MEMORANDUM

TO: District of Columbia Board of Zoning Adjustment
FROM: Arthur Jackson, Development Review Specialist
 Joel Lawson, Associate Director Development Review
DATE: June 3, 2014
SUBJECT: **BZA Case 18774** – request for special exception relief in accordance with § 223 to construct additions to an existing flat in a three-story row dwelling at 2819 13th Street NW

ROOF PLAN

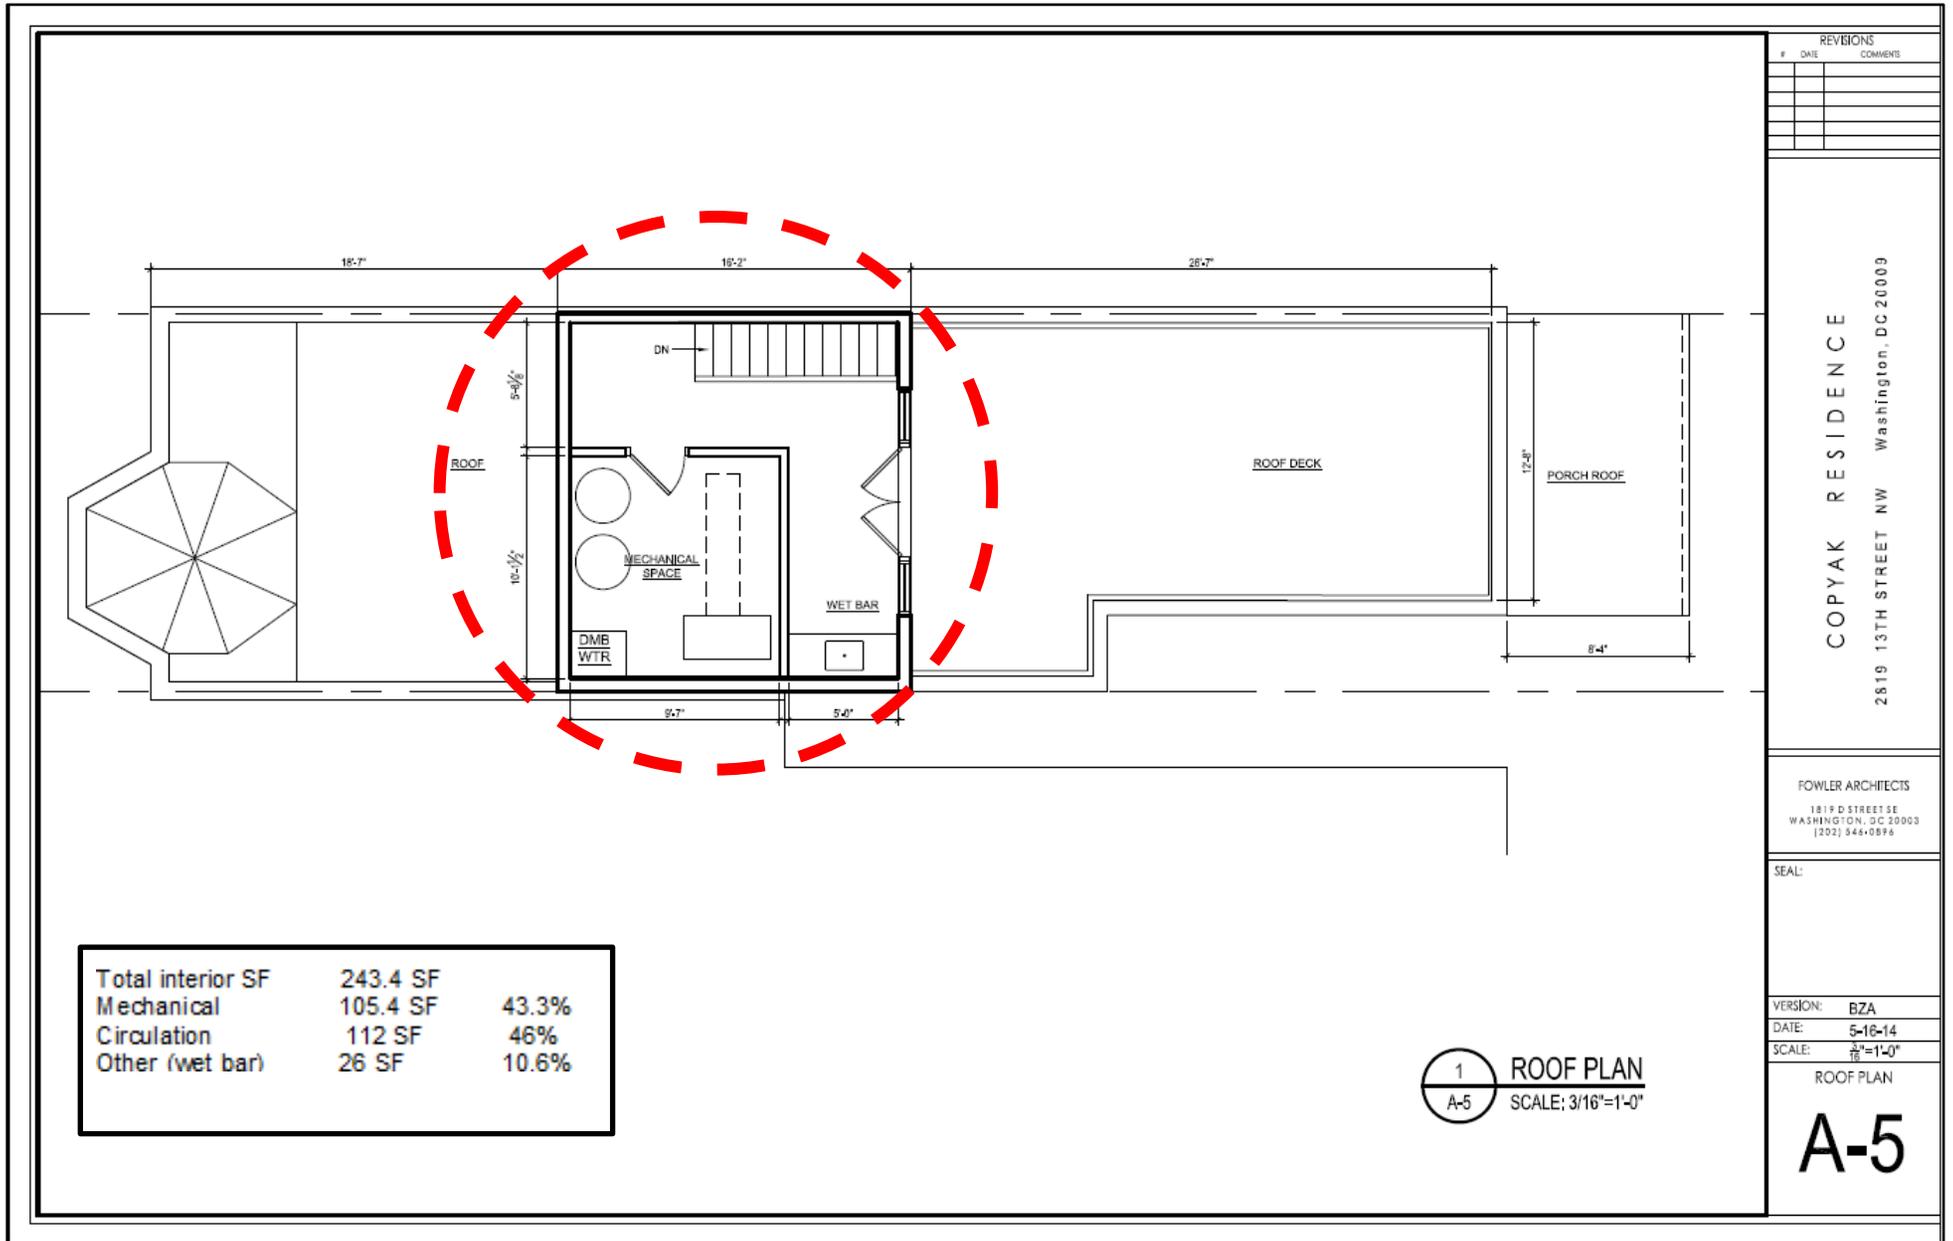
The proposed mixture of exterior building materials would be consistent with nearby row dwellings. The application also stated that new brickwork would be painted to match the existing bricks. The penthouse would set back over 18 feet behind the front façade and the proposed increase in the garage height should have minimum visual impact from the adjacent alley.
